LANDMARK INDUSTRIAL PARK SUBDIVISION,

UNIT III, PHASE II

APPLICATION NUMBER 8 DATE March 16, 2006

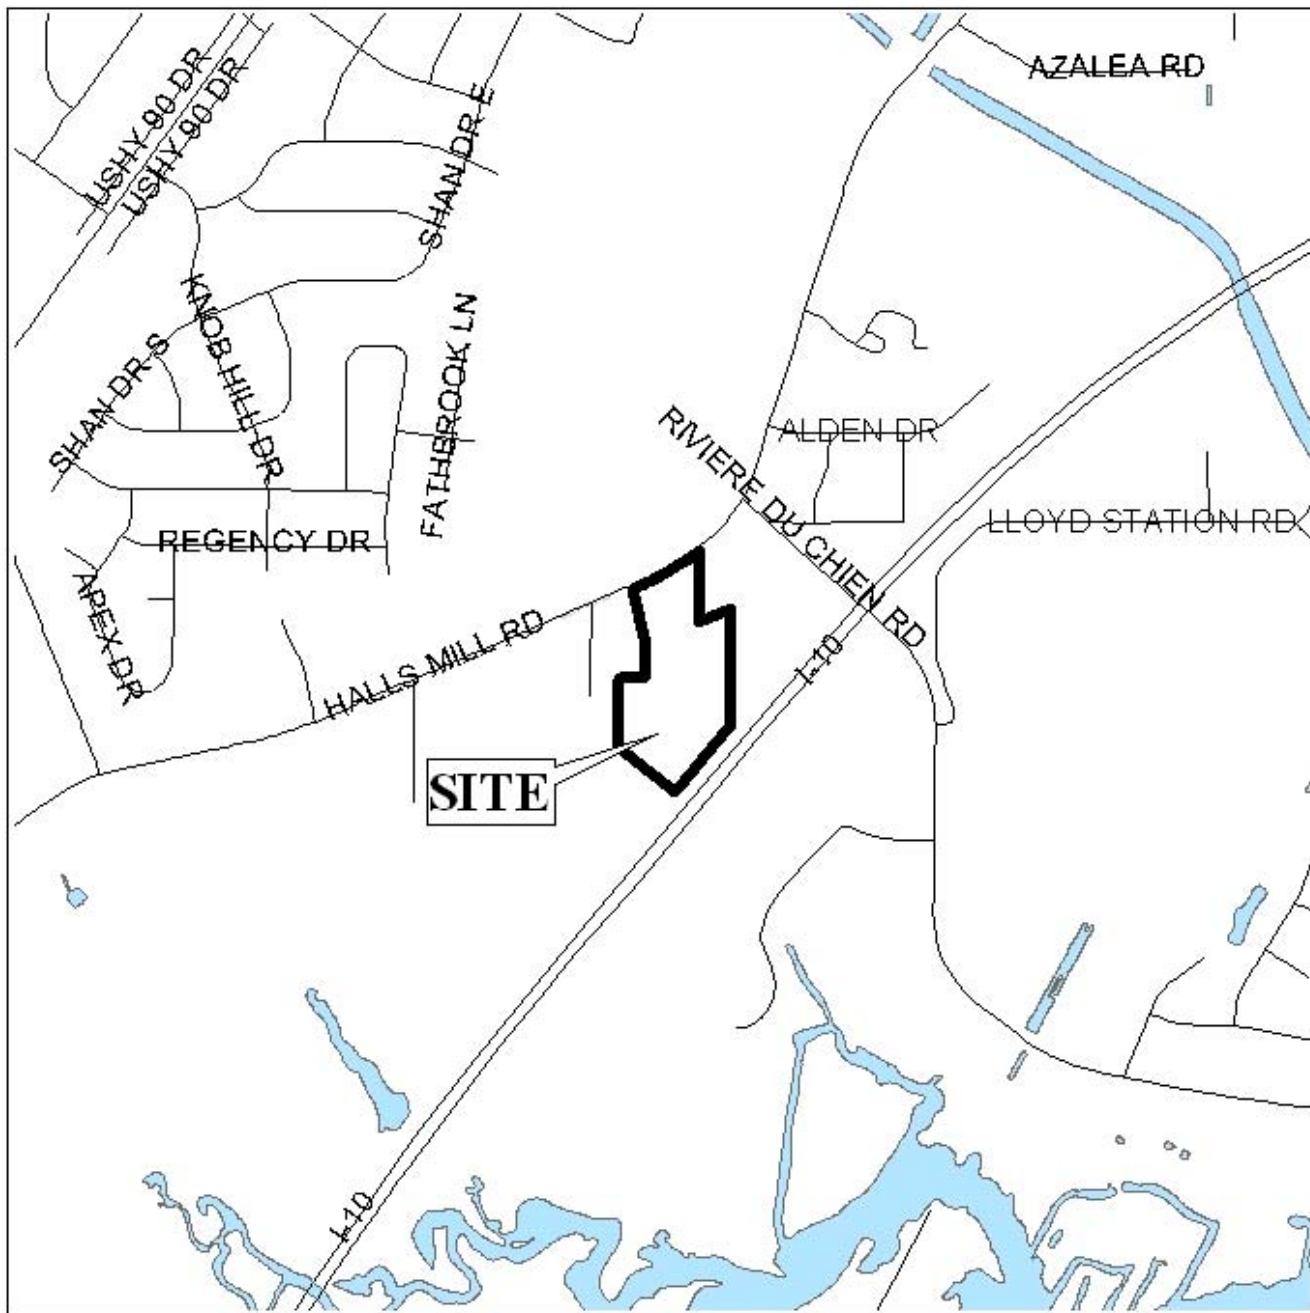
The site fronts Halls Mill Road, which has an existing right-of-way of 60-feet, is a collector street and as such requires a 70-foot right-of-way; therefore, dedication of sufficient right-of-way to provide 35-feet from the centerline should be required.

The plat illustrates four flag-shaped lots (Lots 3, 4, 5, and 6), which are not typical of the area; however, existing and required drainage easements, the floodplain and a culvert cause development hardships and appear to require such a configuration. These lots would require a waiver of Section V.D.3. (maximum depth) of the Subdivision Regulations.

In the earlier application, allowing flag lots was mitigated by limiting curb cuts and allowing shared access between the lots. As before, a note should be required on the final plat stating that the site, *including Lot 1 from Phase I*, is limited to two curb cuts, with size, design and location to be approved by Traffic Engineering. In addition, as before, an Administrative Planned Unit Development application will be required, to provide for shared access between lots.

The final plat should also illustrate the building setback for the flag-shaped lots at the point where each lot is at least 60 feet wide.

With a waiver of Section V.D.3. (maximum depth), the plat will meet the minimum requirements of the Subdivision Regulations and is recommended for Tentative Approval, subject to the following conditions: 1) dedication sufficient to provide 35 feet from the centerline of Halls Mill Road; 2) the placement of a note on the final plat stating that an Administrative Planned Unit Development application must be submitted as lots are developed, to provide for shared access between lots; 3) all lots are to be recorded at the same time; 4) the placement of a note on the final plat stating that the site, including Lot 1 of Phase I, is limited to two curb cuts, with size, design and location to be approved by Traffic Engineering; 5) the placement of a note on the final plat stating that there will be no further resubdivision of the lots; 6) the placement of the setback lines on the final plat where the flag-shaped lots are at least 60 feet wide; and 7) the placement of a note on the final plat stating that approval by all applicable federal, state, and local agencies will be required prior to the issuance of any permits, due to the site's location in the floodplain.
